Addendum No. 02

Subject: John F. Hartranft School

SDP Contract No. B-056, B-057C, B-058C of 18/19

UNI-VENT & TEMPERATURE CONTROL REPLACEMENT

ELECTRICAL SYMBOLS, NOTES AND ABBREVIATIONS

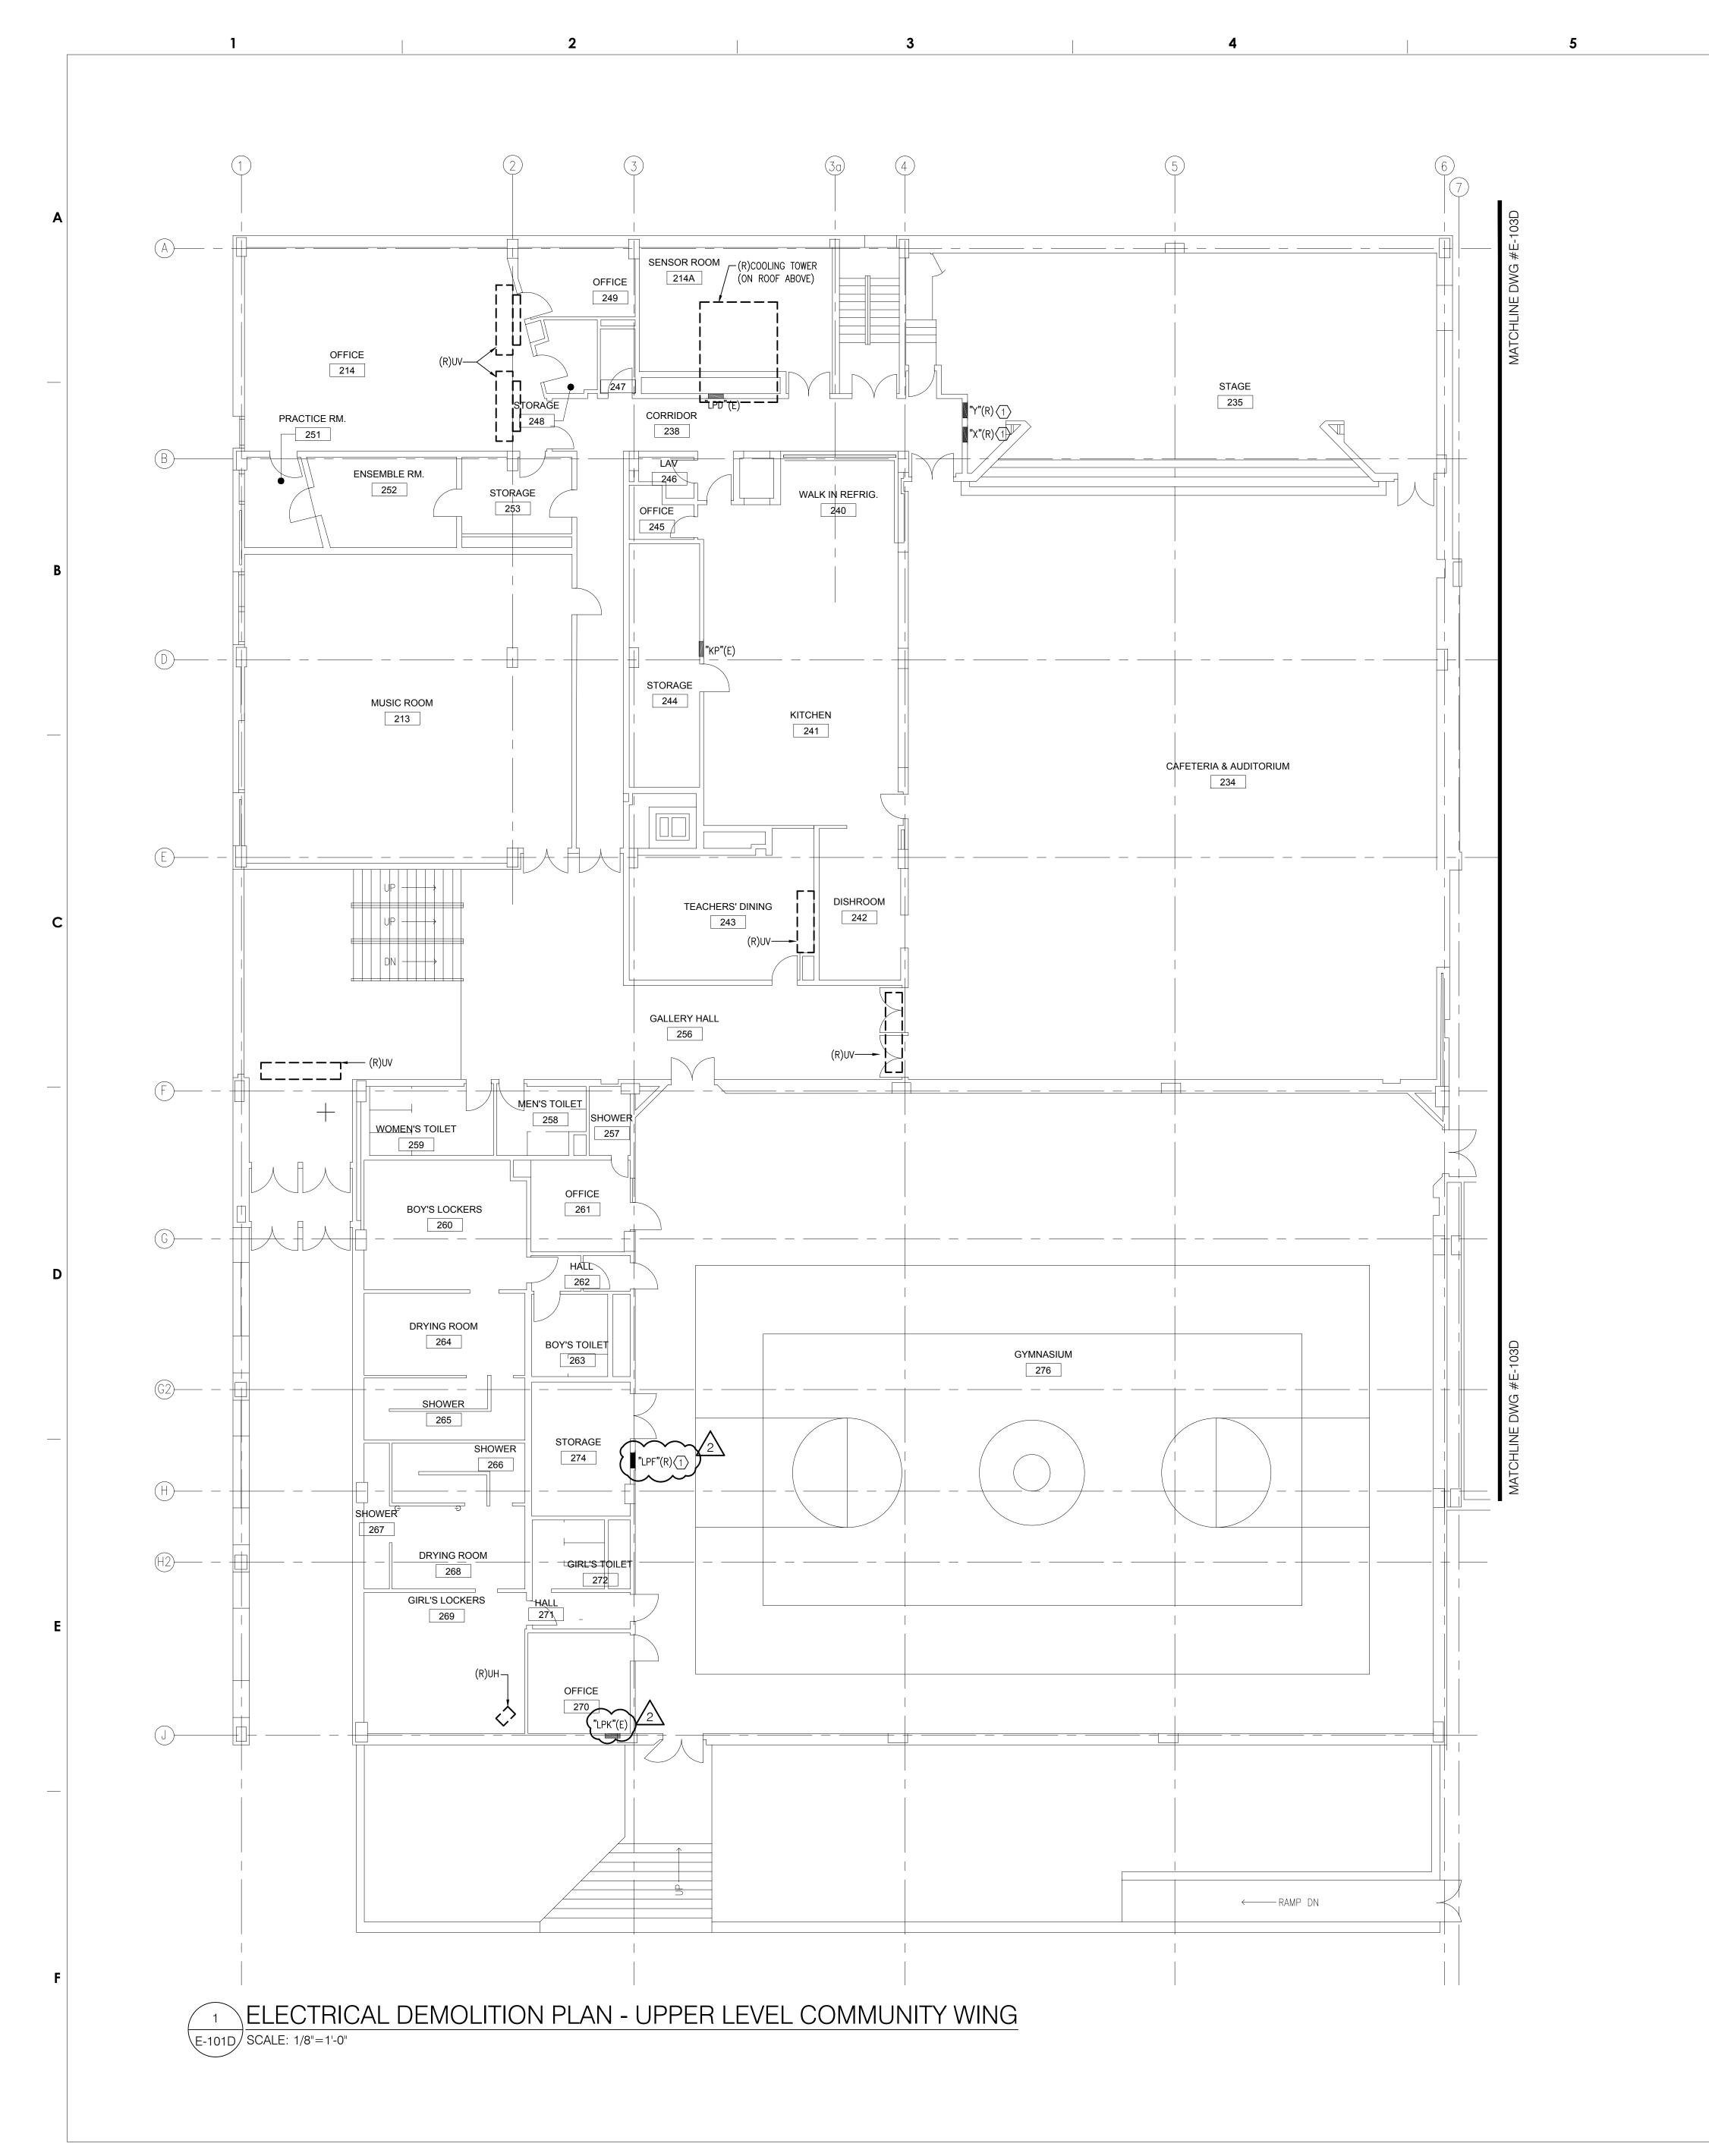
The response to Addendum 01 question #7 says to follow to the spec for raceway application. The spec says all panelboard feeders are to be in GRC conduit. The revised note 1 on E-001 says to provide EMT for feeder wiring where not subject to physical damage. Please clarify feeder conduit type for locations not subject to physical damage.

Addendum 1 states there is a feeder schedule on E-001, I do not see a feeder schedule, please provide.

Specification will take precedence. See Addendum #2 drawings, Sheet E-001 for note revision.

This should have been addressed in Addendum #1. See Addendum #2 drawings, Sheet E-001.

DRAWING NO. E-101D

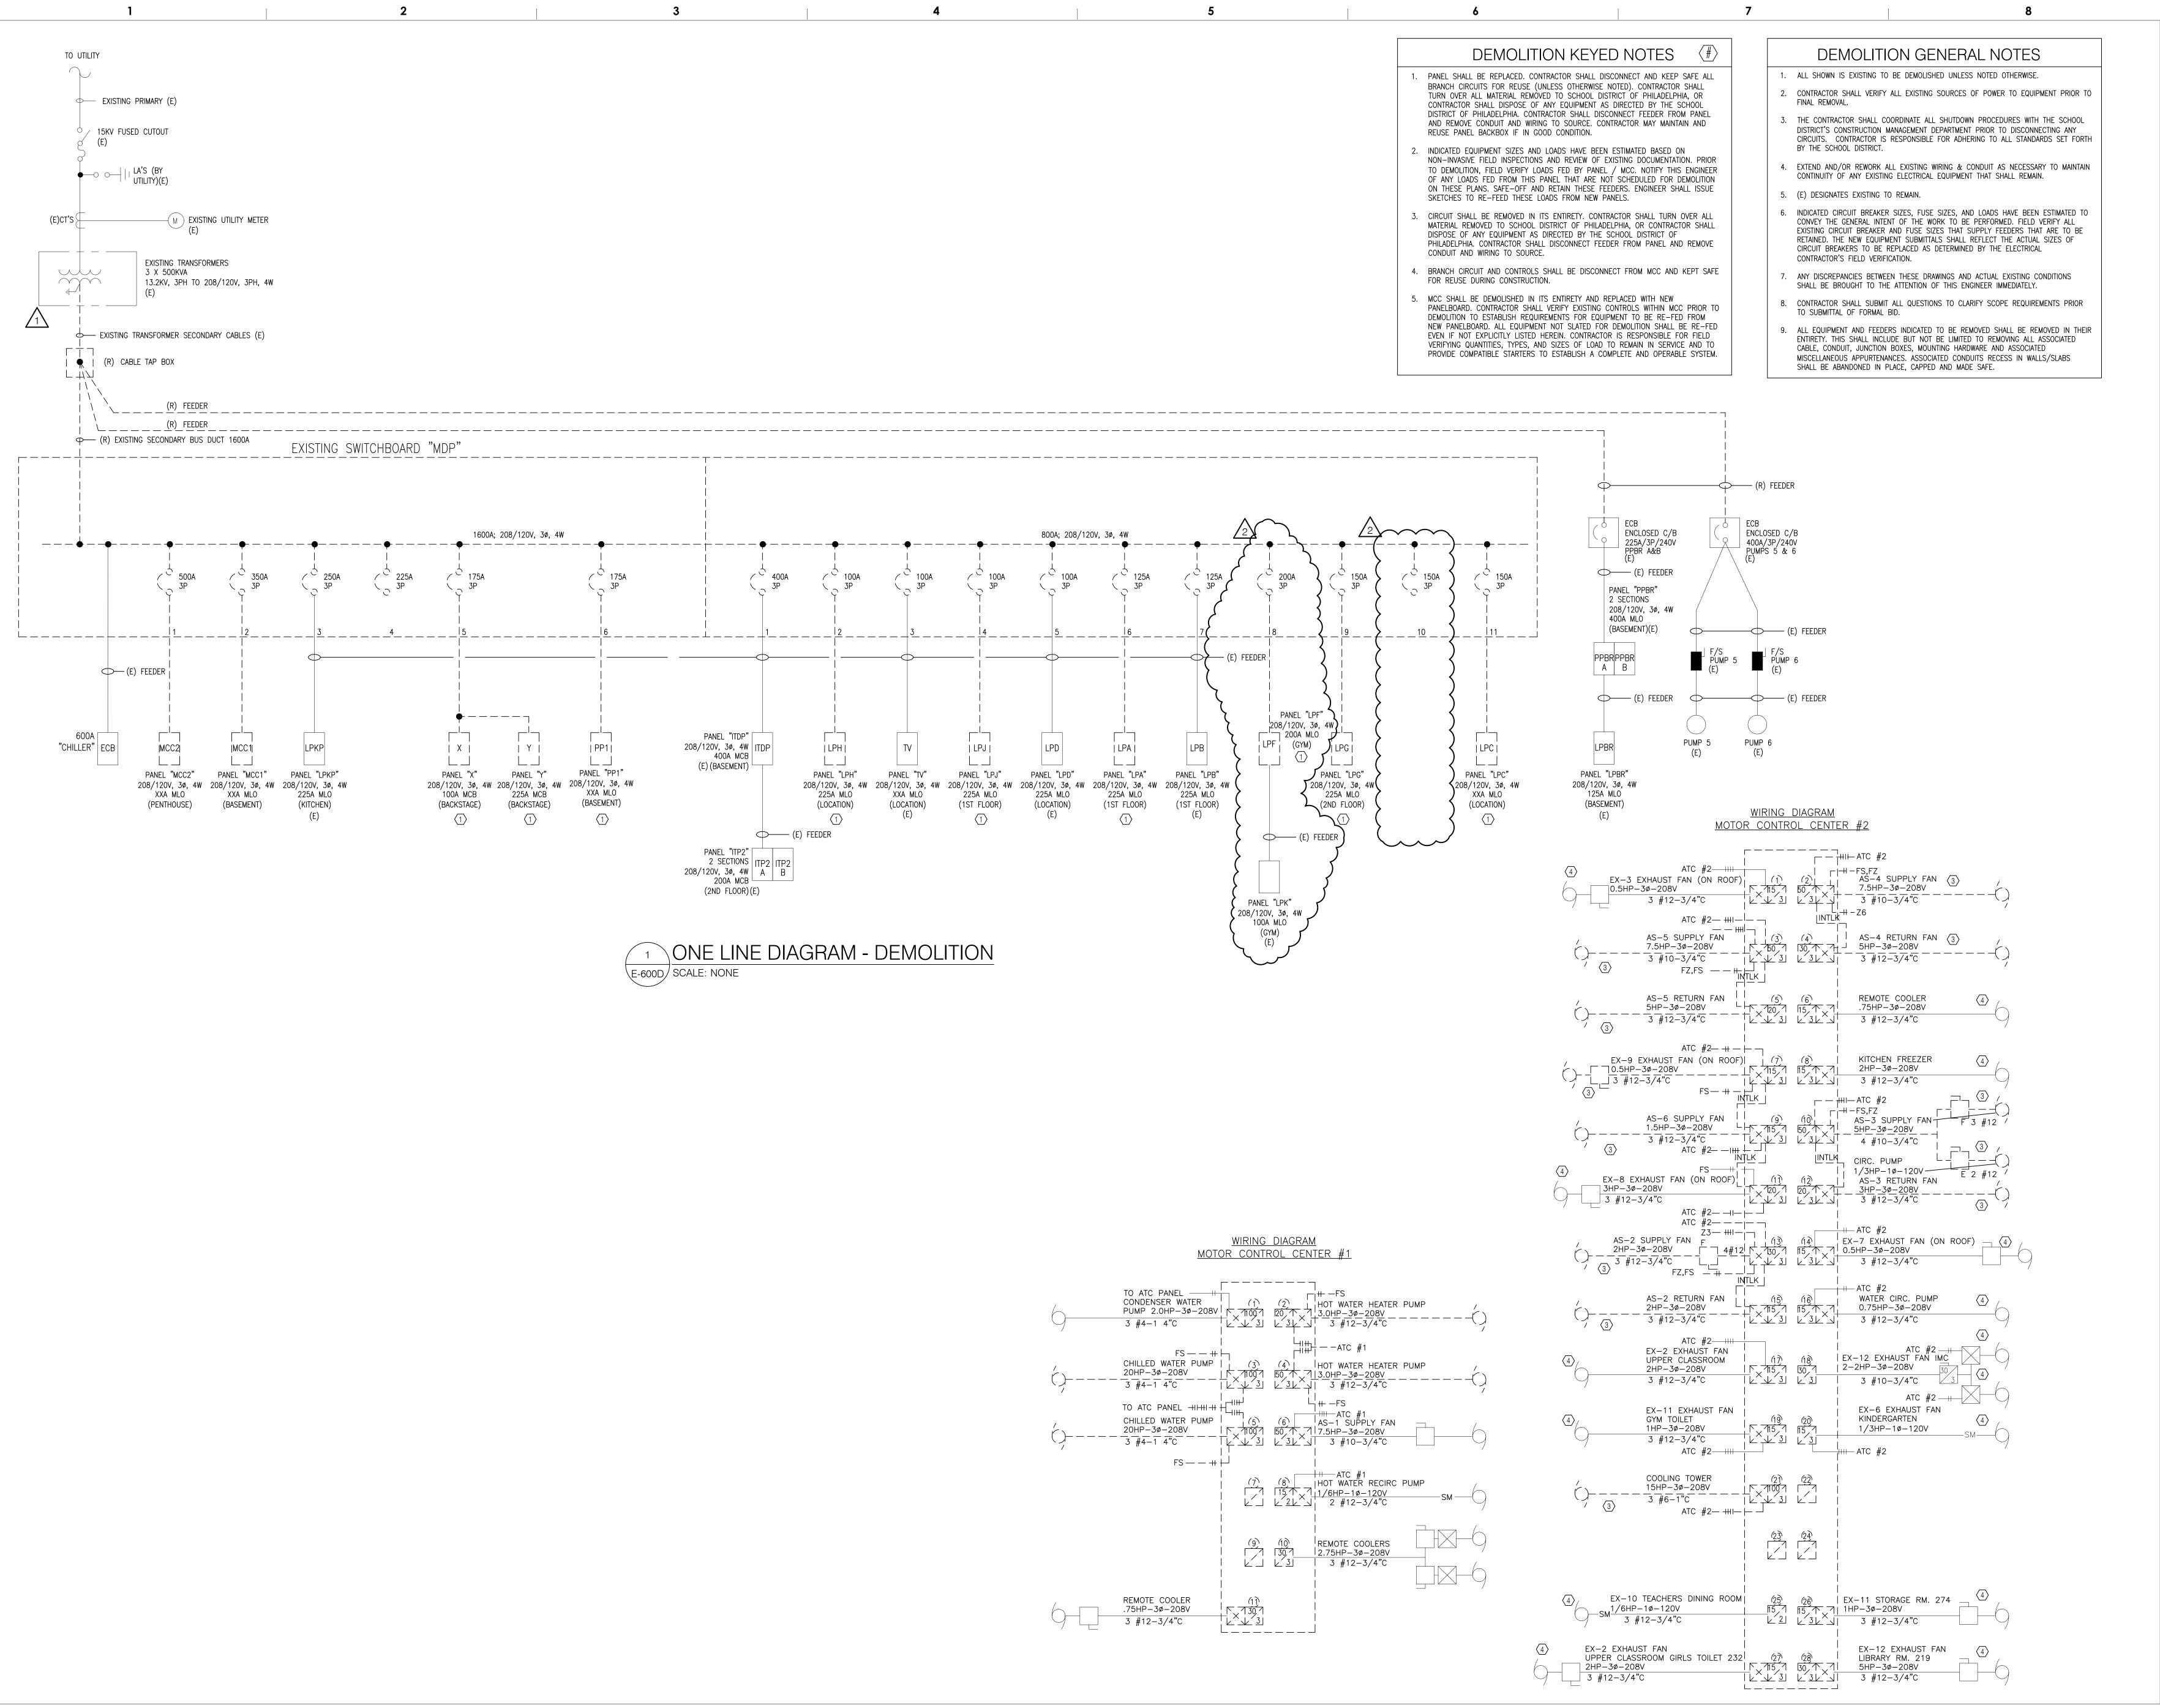
On E-101, there is a panel in the gym labeled "LPF" (N) with keynote 1. I believe this should be labeled as "LPE", because on E-101D the gym panel is labeled "LPE" (R) with keynote 1, and because another panel "LPF" is shown elsewhere. Panel LPE is not shown on the single line on E-600. Panel LPE is shown with keynote (1) on the demo single line on E-600D (the rectangle is labeled as "LPC" but the label underneath is shown as "LPE"). Please clarify if we are to replace panel "LPE" in kind. Please provide panel schedule. Please clarify where LPE is fed from and include the feeder size.

See Addendum #2 drawings, Sheets E-101D, E-600D, E-100, E-600, and E-601.
